Record Drawing

COVER SHEET SANITARY SEWER PLANS	2019
	EE'S SUMMIT MO

WOODSIDE RIDGE
FIRST PLAT

SHEET
C211

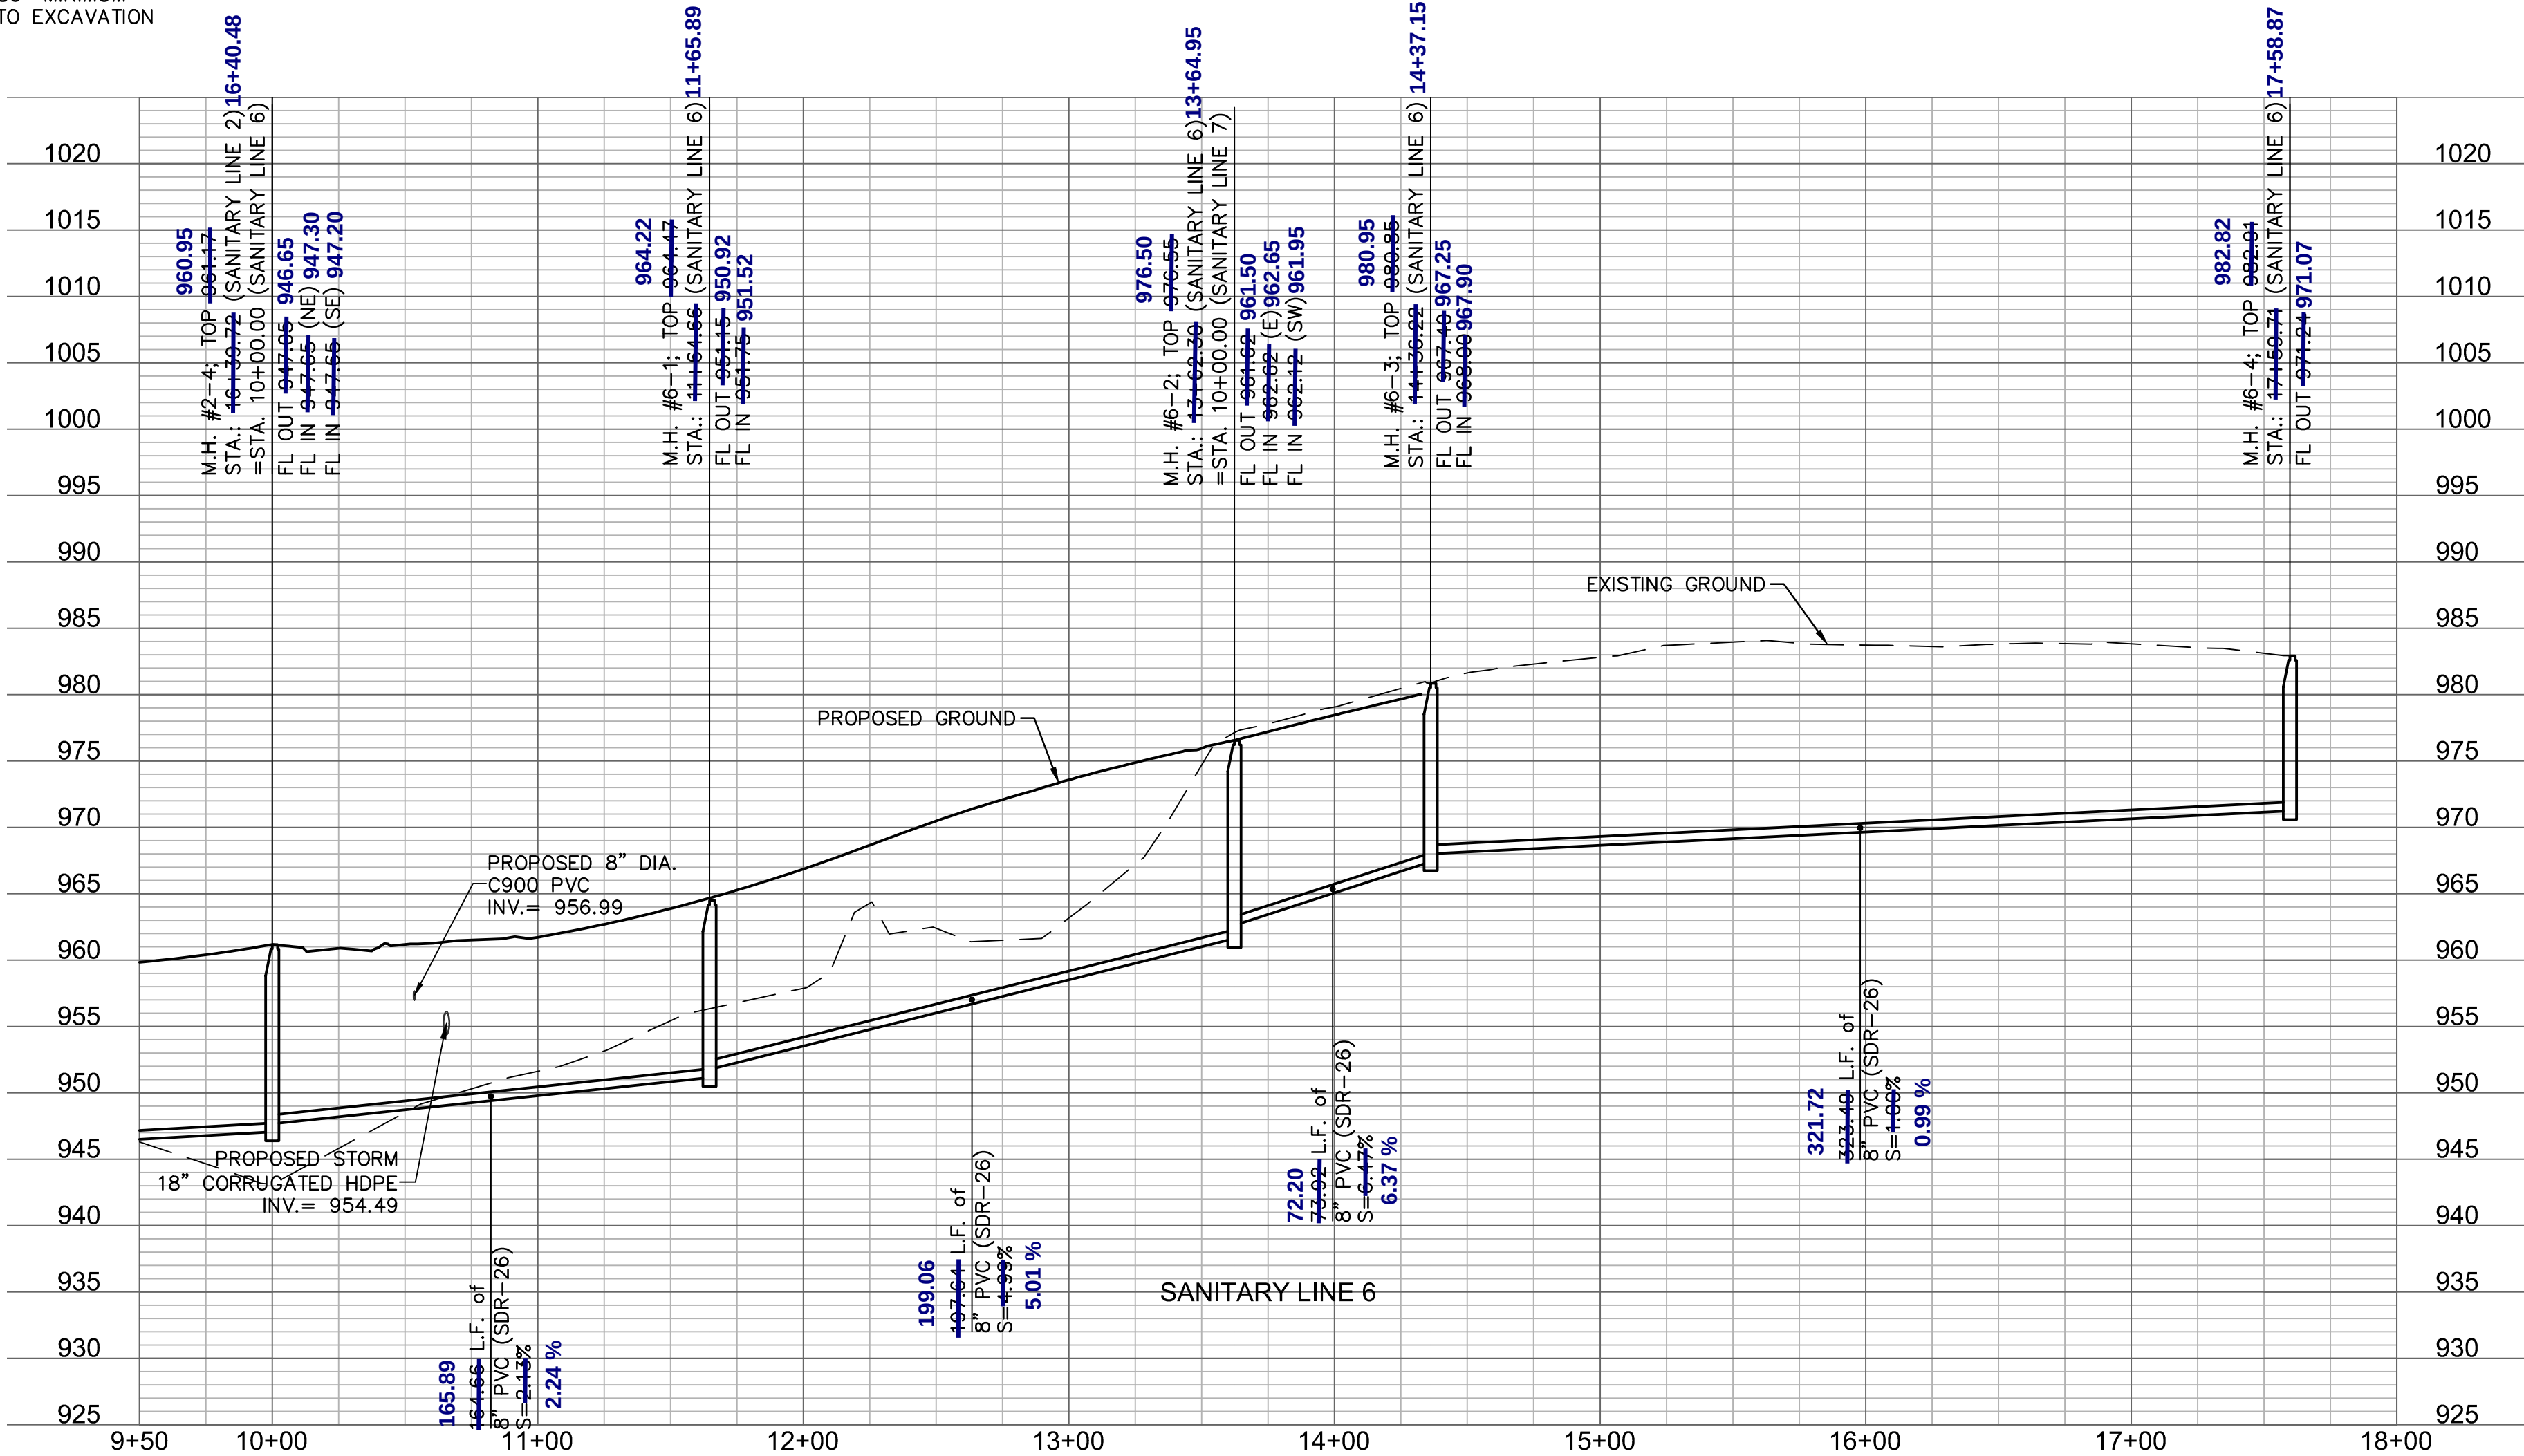
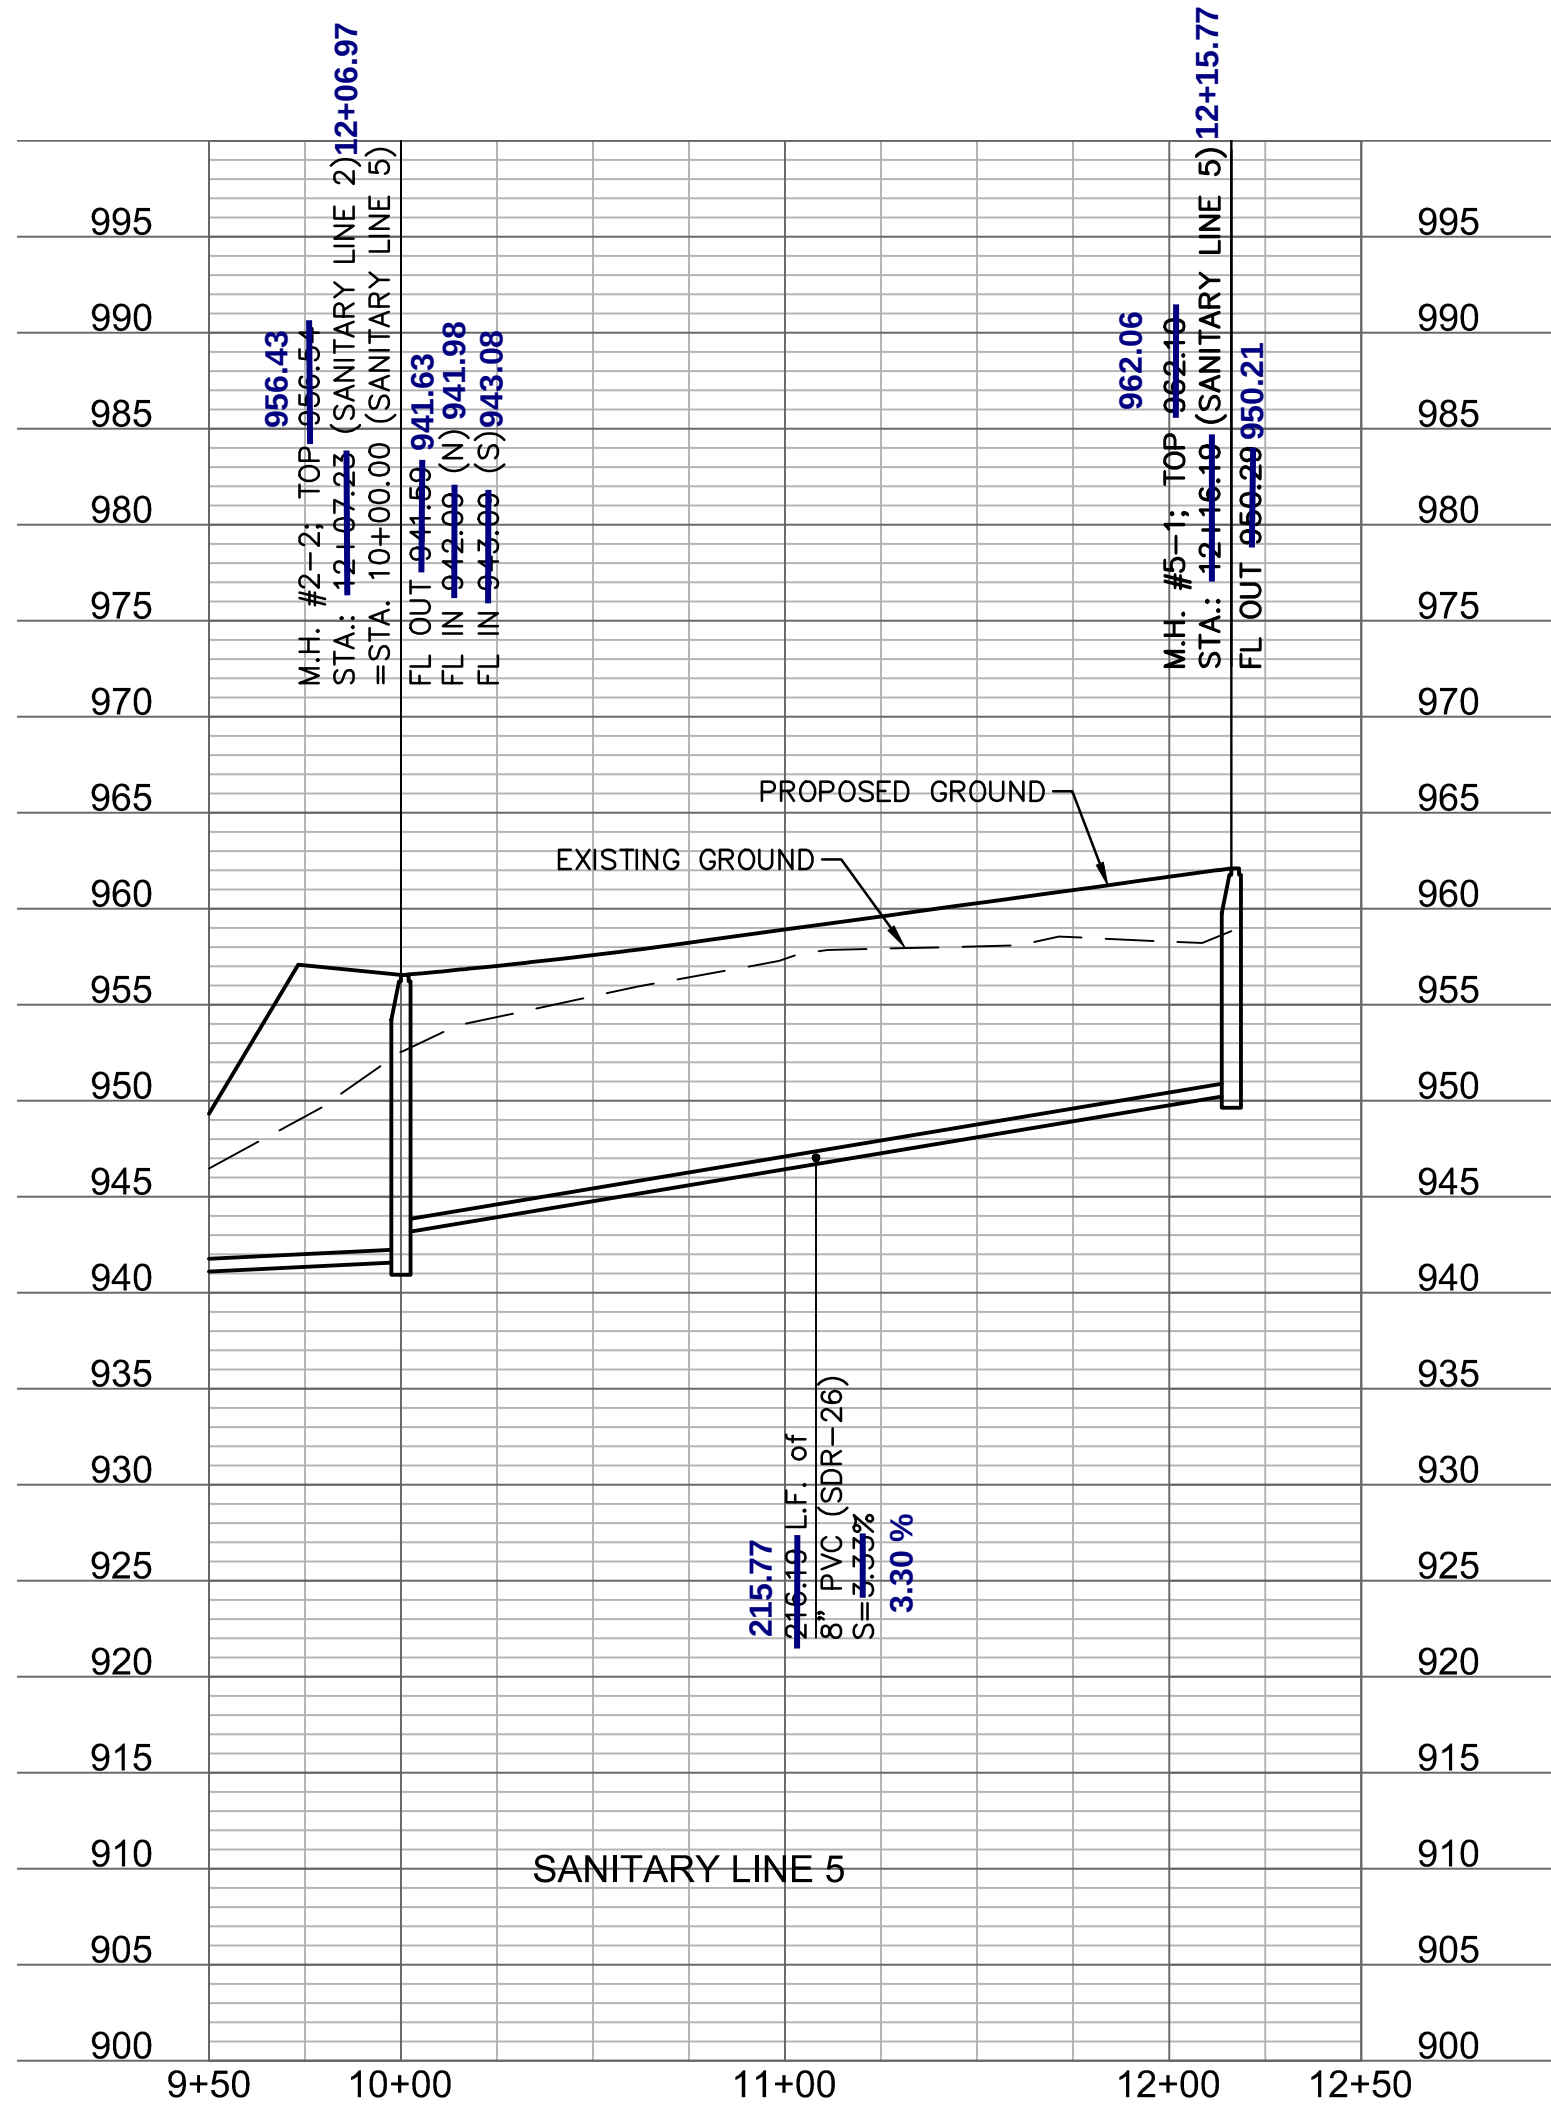
As-built is 0.26' N and 1.48' W of plan
M.H. #2-2, CONST. STD. SANITARY MANHOLE (4' DIA. INSIDE)
STA.: ~~12+07.23~~ (SANITARY LINE 2)
=STA.: 10+00.00 (SANITARY LINE 5)
=STA.: ~~13+73.44~~ (C) 13+73.26
NW JOSHUA DRIVE, ~~28.26~~ LT 29.77

As-built is 0.64' N and 0.89' W of plan
M.H. #5-1, CONST. STD. SANITARY MANHOLE (4' DIA. INSIDE)
STA.: ~~12+16.19~~ (SANITARY LINE 5)
=STA.: ~~11+64.34~~ (C) 11+64.94
NW JOSHUA DRIVE, ~~25.00~~ LT 25.91'

As-built is 0.70' N and 0.10' E of plan
M.H. #6-1, CONST. STD. SANITARY MANHOLE (4' DIA. INSIDE)
STA.: ~~11+64.66~~ (SANITARY LINE 6)
=STA.: ~~11+39.00~~ (C) 11+39.36
NW SHAMROCK AVENUE, ~~33.73~~ LT 34.91'

As-built is 0.09' N and 2.31' E of plan
M.H. #6-2, CONST. STD. SANITARY MANHOLE (4' DIA. INSIDE)
STA.: ~~13+62.36~~ (SANITARY LINE 6)
=STA.: 10+00.00 (SANITARY LINE 7)
=STA.: ~~13+47.43~~ (C) 13+49.87
NW SHAMROCK AVENUE, ~~27.32~~ LT

As-built is 1.34' N and 1.13' W of plan
M.H. #6-4, CONST. STD. SANITARY MANHOLE (4' DIA. INSIDE)
STA.: ~~17+59.74~~ (SANITARY LINE 6)
=STA.: ~~17+59.16~~ (C) 17+58.35
NW SHAMROCK AVENUE, ~~40.63~~ LT

As-built is 0.83' N and 0.41' W of plan
M.H. #2-4, CONST. STD. SANITARY MANHOLE (4' DIA. INSIDE)
STA.: ~~16+39.72~~ (SANITARY LINE 2)
=STA.: 10+00.00 (SANITARY LINE 6)
=STA.: ~~17+93.97~~ (C) 17+94.38
NW JOSHUA DRIVE, ~~25.47~~ LT 26.30'

M.H. #6-3, CONST. STD. SANITARY MANHOLE (4' DIA. INSIDE)
STA.: ~~14+36.22~~ (SANITARY LINE 6)
=STA.: ~~14+31.49~~ (C) 14+32.31
NW SHAMROCK AVENUE, ~~31.64~~ LT
As-built is 1.39' N and 0.69' E of plan
